UNITED STATES DEPARTMENT OF THE INTERIOR **BUREAU OF LAND MANAGEMENT**

SUNDRY NOTICES AND REPORTS ON WELLS OF THE PROPERTY TO BE DO NOT use this form for proposals to drill or to deepen or reentry to a different reservoir. Use "APPLICATION FOR PERMIT—" for such proposals.	5 If Indian. Allones or Tribe Name NA		
SUBMIT IN TRIPLICATE	7 If Unit of CA. Agreement Designation		
1. Type of Well	ROSA		
Out Well Other	8. Weil Name and No.		
2. Name of Operator	7 81		
MITCHELL ENERGY CORPORATION	9 AM Well No.		
3. Address and Telephone No. 555 17th Street - Suite 3500	30-039-22666		
Denver, CO 80202 (303) 292-4455	10 Field and Pool, or Exploratory Area		
4 Location of Well (Footage, Sec., T., R., M., or Survey Description)	Basin Dakota		
1080' FNL & 1100 FEL NENE	11 County or Parish. State		
Sec. 7-T3lN-R4W	Rio Arriba, NM

Mitchell Energy Corporation proposes to plug & abandon the Rosa Unit #81 during September 1991. The proposed work will follow the attached procedure.

Proposed P & A Procedure

PROPOSED PAA SCHEMATIC

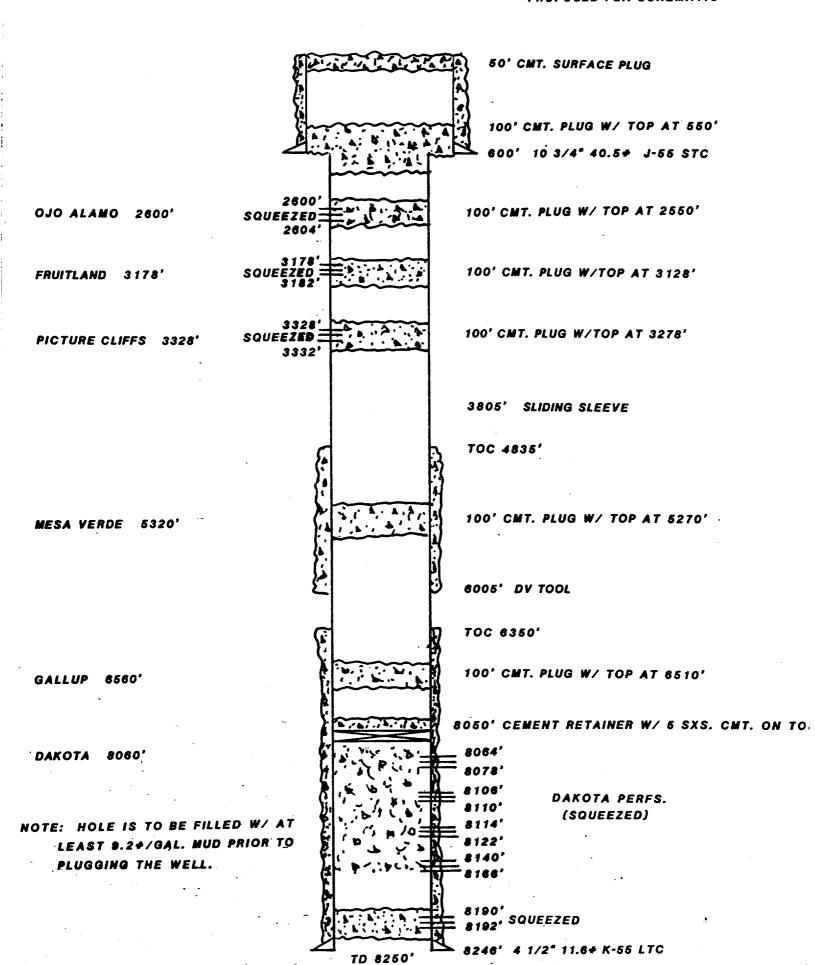
- 1. Plugging operations authorized are subject to the attached "General Requirements for Permanent Abandonment of Wells on Federal Leases."
- 2. Mark Kells with the Farmington Office is to be notified at least 24 hours before the plugging operations commence (505) 326-6201.
- 3. Blowout prevention equipment is required.
- 4. The following modifications to your plugging program are to be made (when applicable):
 - a) Move Protised Cliffs perforts 3378-3382 (50'below Top)

and squeeze is 100% excess

b) move on Alimo perforts to 26507654 (50' below Top)

and squeeze using 100% excess.
